Water Services Resource Consent Conditions – Assessment of Application Rev C

Date: 01 August 2022 updated 12 August 2022, final 24 August 2022

SR510418 – Jervois Quay

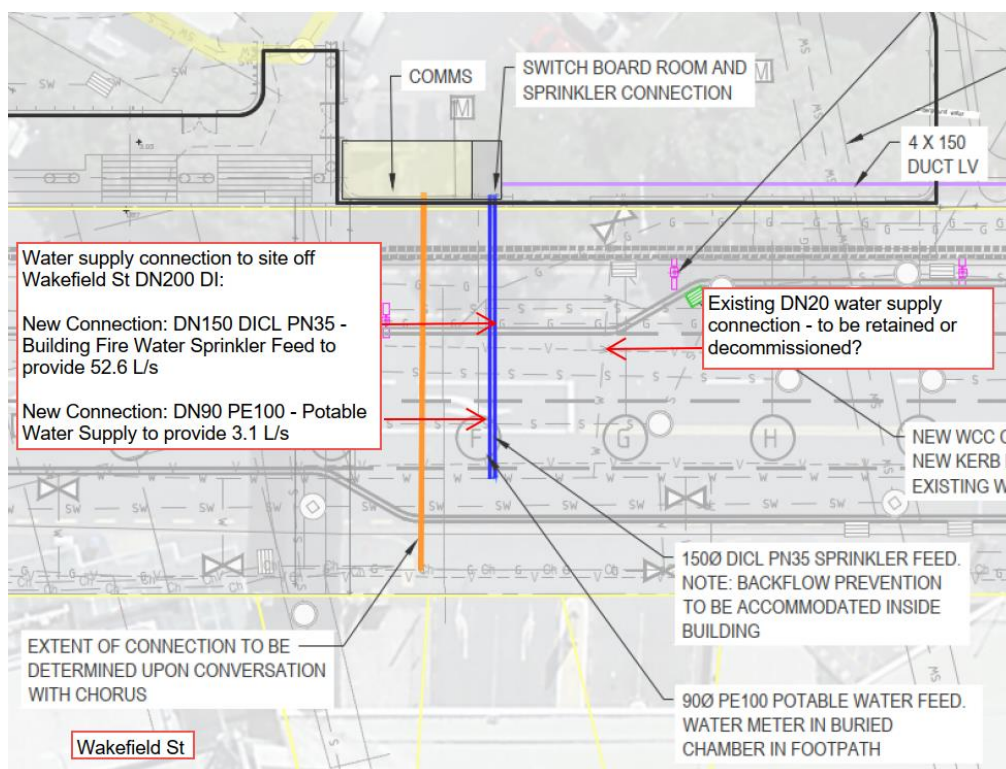
The applicant requires water supply for:

- Potable water supply for new development inhabitants
- Irrigation of the landscaped areas on site
- Building fire water sprinkler system

The applicant has indicated on their drawing (520408-0000-DRG-CC-0010-A) that they intend to install 2 new connections into the Wakefield Street DN200 DI watermain in order to service the development:

- DN150 DI CL PN35 – Building Fire Water Sprinkler Feed
- DN90 PE100 Potable Water Supply

These 2 no. new connections appear to be near the location of the existing DN20 water supply connection off the DN200 DI Wakefield Street watermain. The existing connections are not suitable for re-use and will need to be abandoned.

The WWL modelling team have indicated that there is 75-80 m of pressure in the water supply network at the point connection into the DN200 DI Wakefield Street watermain. This modelling result is based on a 2018 model which does not factor in future and proposed and developments. The applicant has advised a fire demand of 52.6 L/s and a domestic flow of 3.1 L/s. Calculations are required to support the assessment and demonstrate that this can be achieved from the public network.

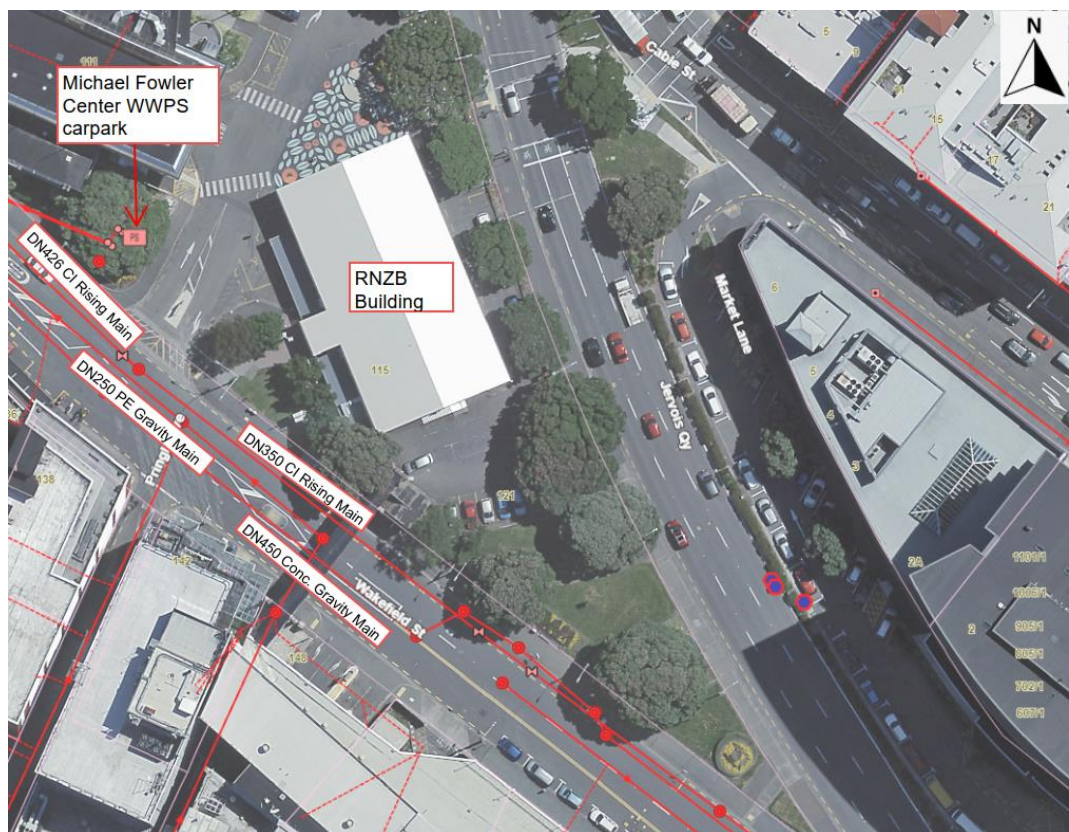
There are numerous wastewater pipes along Wakefield Street.

The applicant indicates that there is an existing WW service lateral which services the RNZB building (DN unknown). The applicant's drawing suggests that this service lateral connects directly in to the existing DN350 CI Rising main on Wakefield Street although, their reporting and labels indicate they have mistaken this to the DN450 Gravity main.

The applicant has indicated that there is an existing WW storage tank onsite. This tank is adjacent to the RNZB building and is beneath a road accessway. The tank provides storage for the adjacent WWPS located in the MFC car park and is a public wastewater asset. WWL have met with the applicant (22 June 2022) and, following receipt of a preliminary seismic assessment and a structural assessment have agreed a build over of the storage tank.

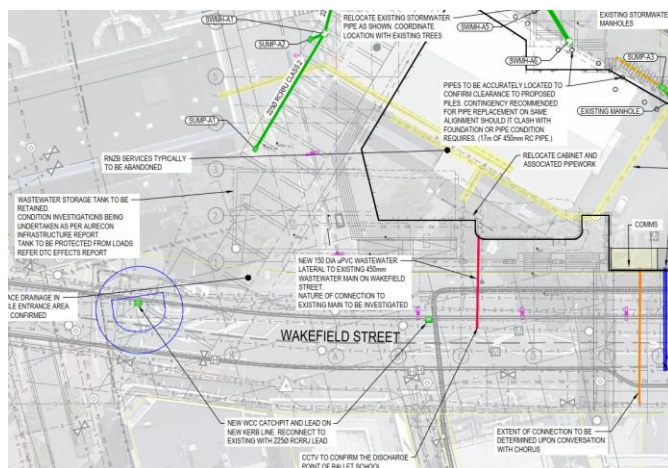
- Tank generally compliant with current codes + sea-level rise + potential hazard changes.
- The base of the tank is adequately socketed into the underlying alluviums (below potential liquefaction) to prevent lateral displacement of the tank.

- Unbalanced, seismically induced lateral earth pressures may result in minor settlements (50-100mm) across (or along) the tank. This could result in a small tilt (approx. 0.5 degrees max).

- Tank displacements minimal, proposed pile clearances are satisfactory.
- Flexural demands on tank due to passive soil pressures and pile reactions (for a 1-in-1000 year event) are well within existing tank capacity.

- It is apparent that original design allowed for worst case buoyancy (water at ground level).
- Removal of overburden at eastern end of tank (where proposed to build over) may reduce factors of safety below minimum. Anchor piles or ballast may be required.

At detailed design the design must ensure:

- 24/7 access to the tank for heavy vehicles must be maintained at all times.
- WWL need to be able to safely undertake long term repairs / refurbishment / renewal. An easement should be granted in favour of WCC to ensure the access.
- The building tenants recognise that this a critical infrastructure item which is prone to noisy / smelly maintenance from time to time.

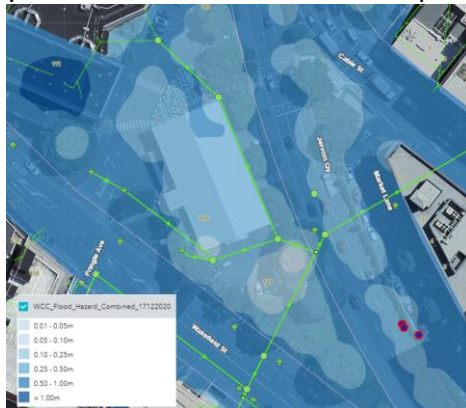
WWL flood maps indicate that the site is at risk of flood (0.01 – 0.5m) during 1/100 year flood events. The flood maps indicate the flooding varies across the site.

The applicant has undertaken some initial flood risk assessment (Aurecon). Simulations were run for 1/100 ARI event with allowance for the effects of climate change. Model results indicate:

- 20 mm increase for 10 year ARI + Climate change
- 30 mm increase for 100 year ARI + Climate change

These results indicate that most existing buildings in the area of the proposed development can be expected to flood in a 100yr ARI+CC event. The results have been demonstrated to be less than minor and as the flooding in this area is largely tidal it is not considered that further mitigation is required.

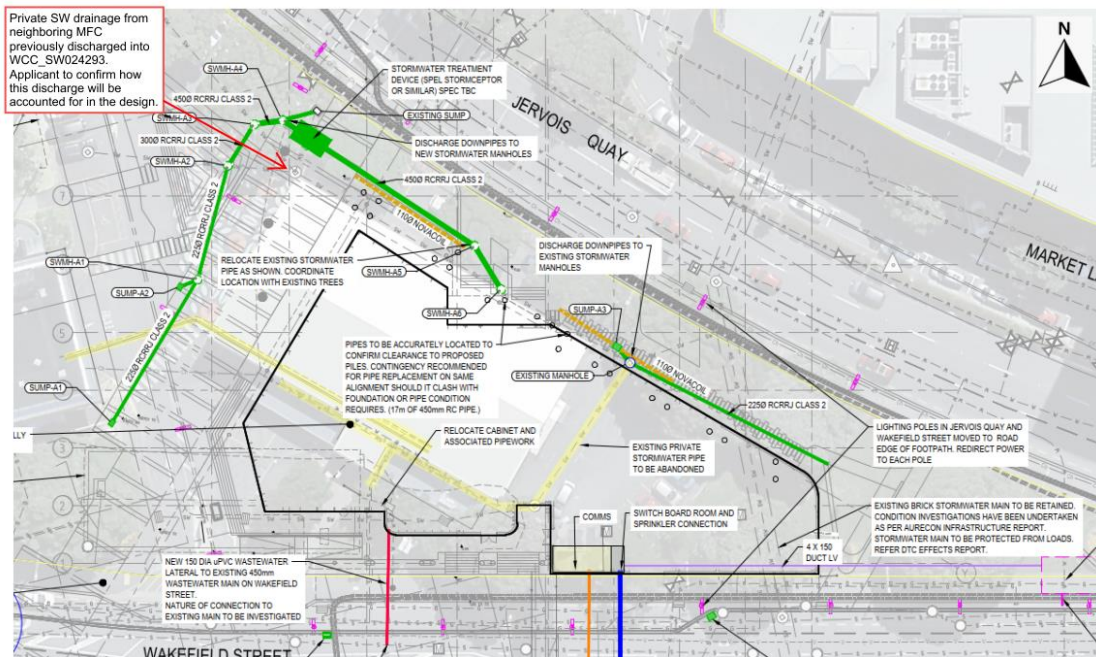
- The limited fetch length of approximately 10km, which is not expected to create waves large and powerful enough to reach the building.

- The extreme storm conditions are to coincide with MHWS and high tide window. The joint probability of occurrence reduces the likelihood of such an event.
- The large number of buildings and barriers to pass (i.e. Frank Kitts Park, Rowing Club, Wharewaka Building, lagoon, pedestrian overbridge, vegetation). These structures will cause the waves to break and diffract (curve around structures), which reduces the wave height.

This assessment is accepted and it is not considered necessary to increase the freeboard for potential wave action.

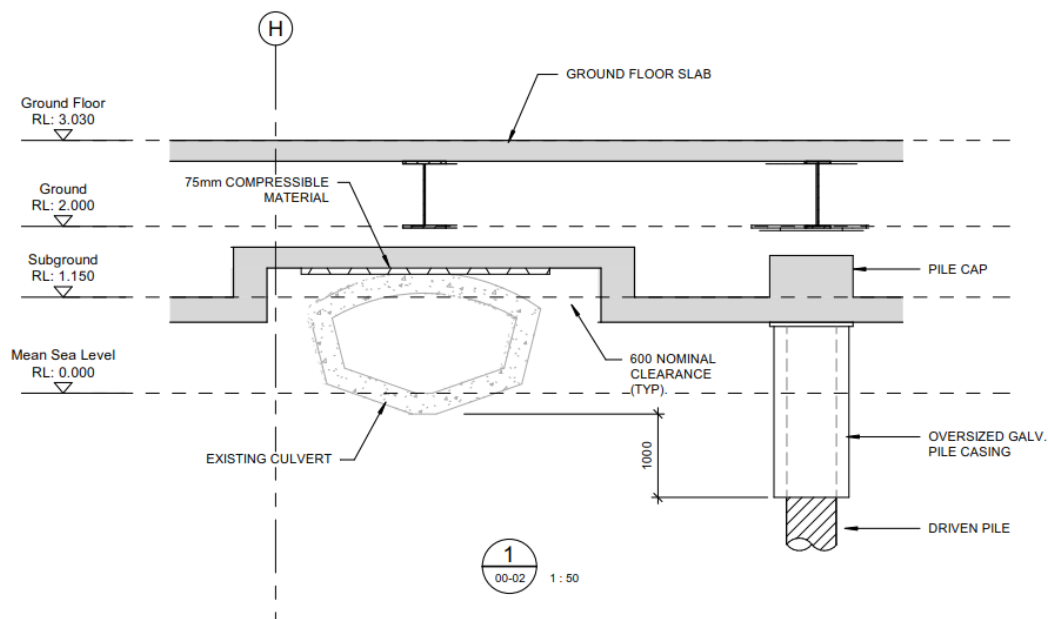
WWL have confirmed (email correspondence, Samir Hermiz) that construction over/replacement/rehabilitation of the the existing ovoid main requires specialist input and design. WWL confirm the downstream ovoid stormwater main is at full

capacity during SW events – SW neutrality or betterment for this development is required as a result.

The applicant is proposing to retain the existing ovoid stormwater main and has designed the building to allow long term maintenance access to be retained such that the main can be repaired in the future if required.

The principles of the proposed design are:

- the final structural bay at the eastern end of the building would be cantilevered from L1 up, such that no foundations would be built over the culvert.
- the ground floor would be constructed of easily demountable walls and a lightweight surface treatment (e.g. similar to pavement) would form the floor, allowing easy access for any work required on the culvert in the future.
- the space would be used by building occupiers for bike parking or something similar – a use which can be relatively easily relocated at short notice.
- the cost of demounting and reconstructing this space would fall to the building owner. This would be captured in an easement instrument which would also protect WW's rights to access and repair/maintain the culvert.

The ovoid pipe has an IL of approximately 0 m and with the building construction will be approximately 3 m below the ground floor slab. The Regional Specification for Water Services drawing DR09 any building above the main would need to be at least 4m above the proposed ground level (depth to IL + 1m). This would put the L1 cantilever at 7 m RL to the underside of the floor slab.

No planting will be accepted over the ovoid pipe.
